Reissue of  
Patent No.: 5,592,811 : Issued: January 14, 1997

For: Method and Apparatus for the  
Destruction of Volatile Organic  
Compounds

PRELIMINARY AMENDMENT UNDER 37 C.F.R. § 1.173(b)

FIG. 5

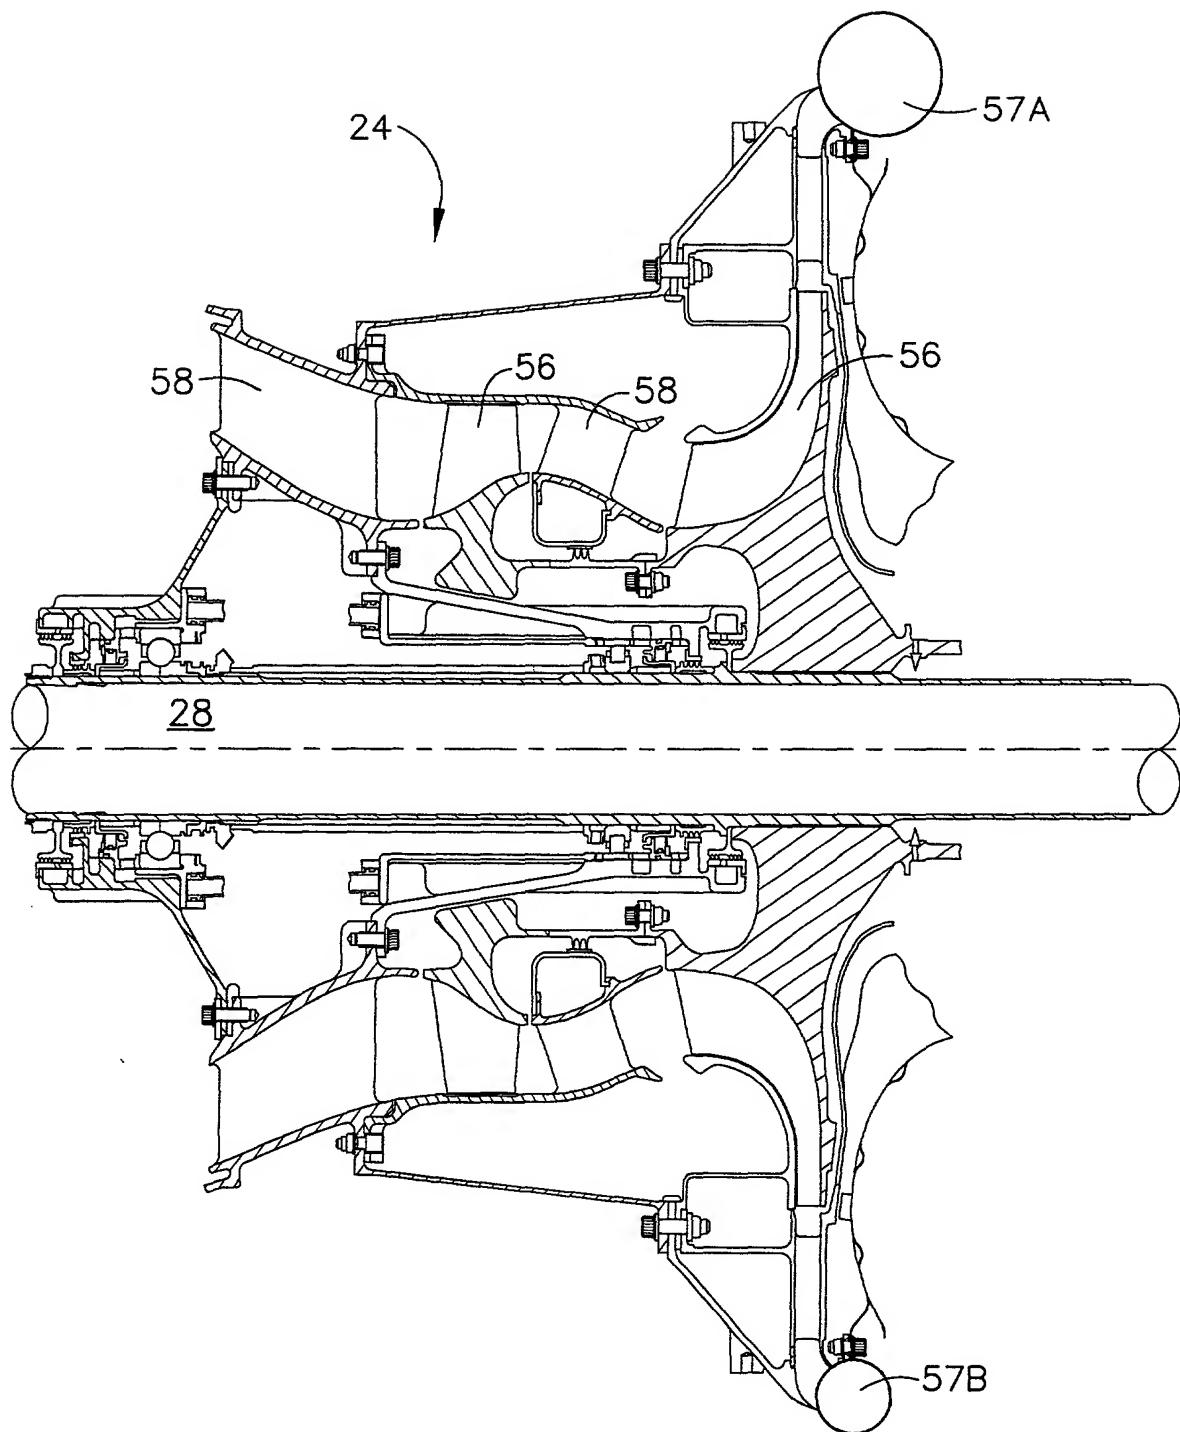
Please cancel Figure 5 in the previously issued patent.

Formal drawings are submitted herewith, in addition to a proposed drawing correction to Figure 5.

A new formal drawing to replace Figure 5 has been submitted. The incorrect Figure 5 in the previously issued patent inadvertently depicted a turbine and turbine blades rather than a compressor and compressor blades. The new Figure 5 submitted herewith depicts a compressor and compressor blades consistent with the specification in the previously issued patent. The

new Figure 5 also shows reference number 24 indicating the compressor, which is also consistent with the specification in the previously issued patent.

proposed corrected drawing
